SUDDRY NOTICES AND REPORTS ON WELLS

RHODES FEDERAL #4-3
UNIT

PROPOSED PROCEDURE FOR PLUG AND ABANDONMENT:

Permanent Abandonment of Federal Wells
Conditions of Approval

Rhodes Federal Unit # ~~43~~ 043

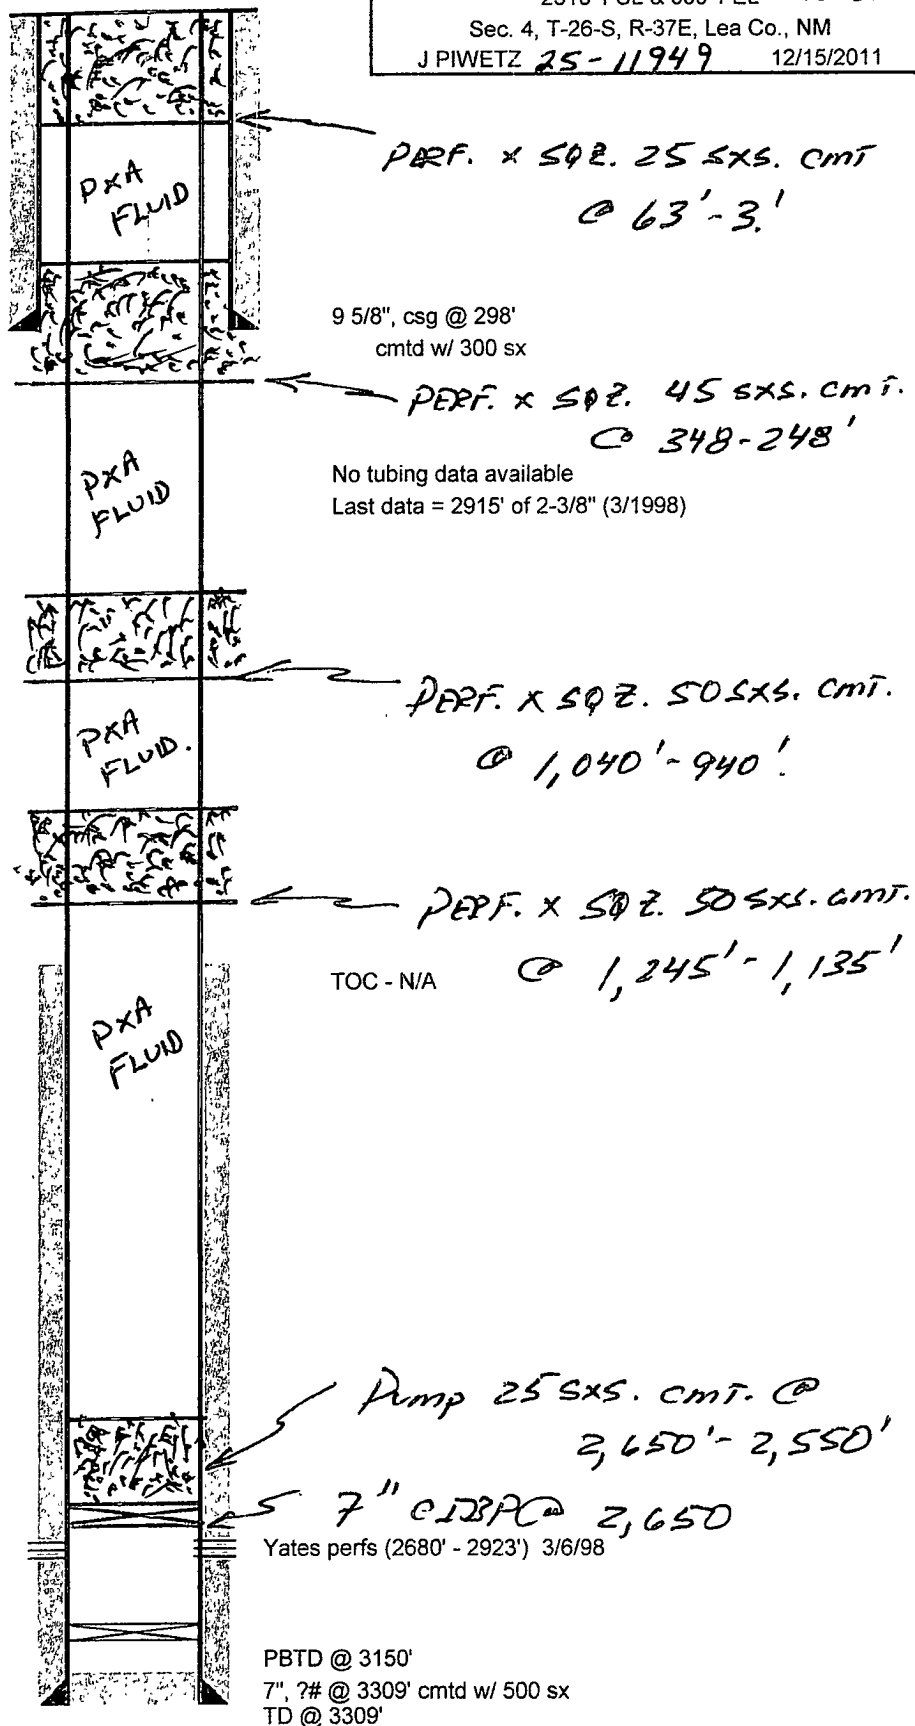
* CIBP @ 3150. Cap w/ 25 SX cmt.

* Ground Level DHM
